MEMORANDUM

TO: Mayor & City Council
FROM: Mary Lou DeWitt, Comm. Dev. Zoning Specialist
SUBJECT: **Preliminary & Final Plat for Rum River, Variance, CUP, and Site Plan Review for Rum River Residential Suites**
DATE: January 11, 2021

Memorandum

To: Mary Lou Dewitt, City of Princeton
From: Jenn Edison, PE – WSB
Date: December 16, 2020
Re: West Rivertown Review
WSB Project No. 017227-000

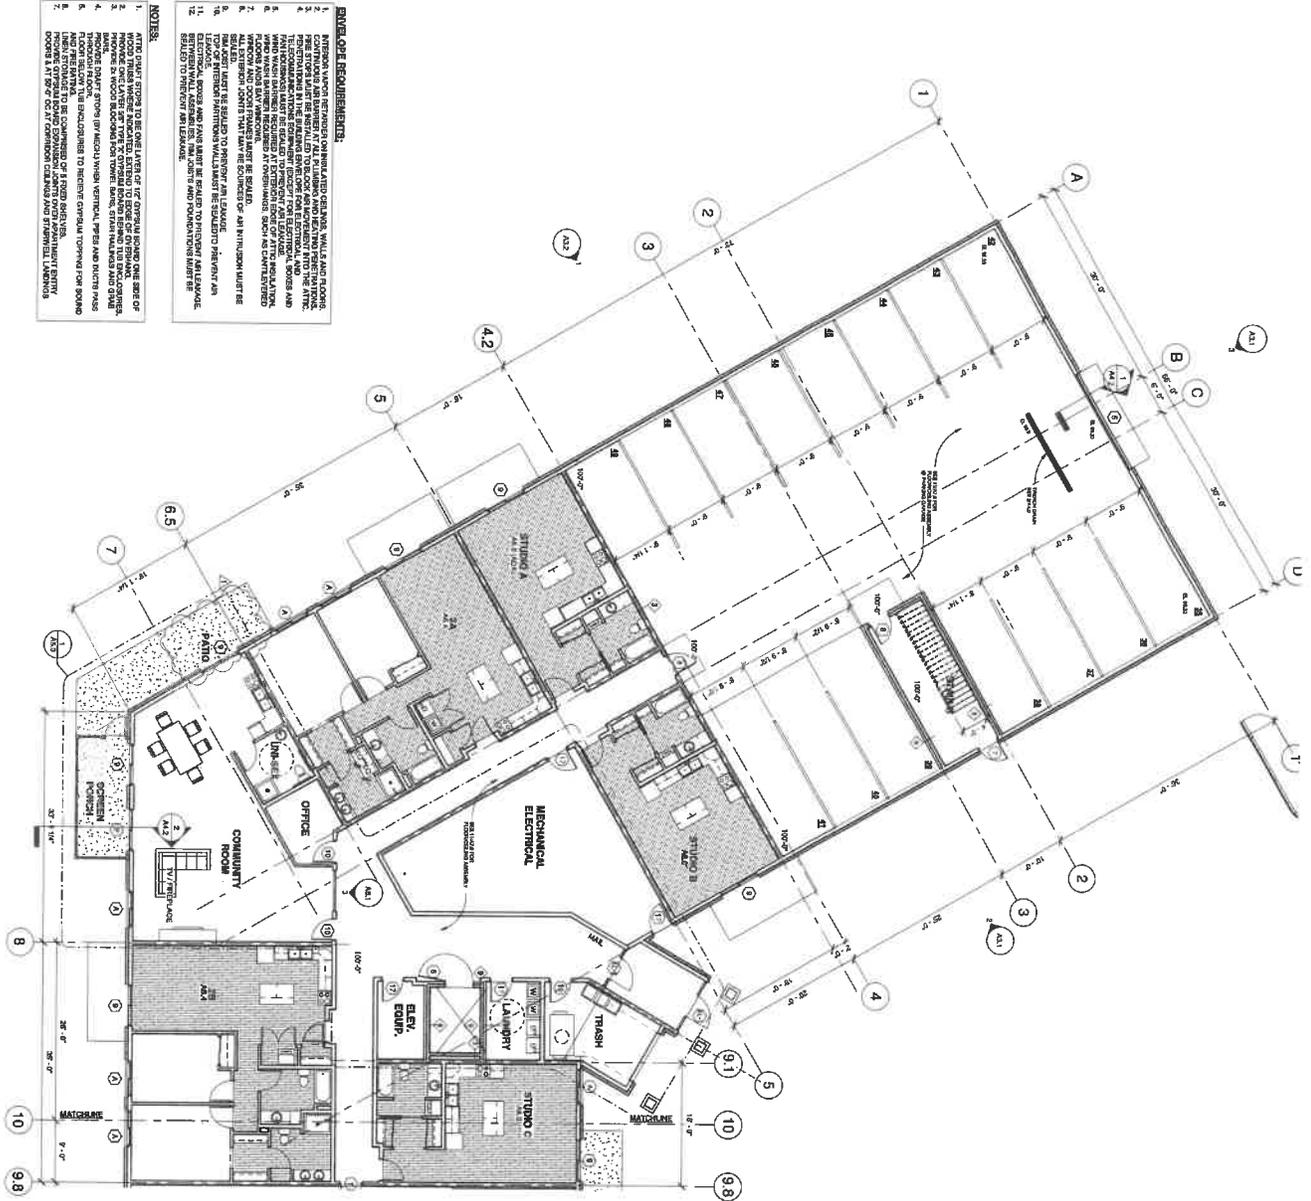
1. Label the pond emergency overflow (EOF) elevations and ensure the EOF is a minimum of 1-foot below the lowest building opening.
2. Label the 100-year HWL on the plans.
 - a. Ensure a 3-foot separation between the lowest building opening and the HWL.
 - b. Ensure a 2-foot separation between the basement and the HWL (if applicable).
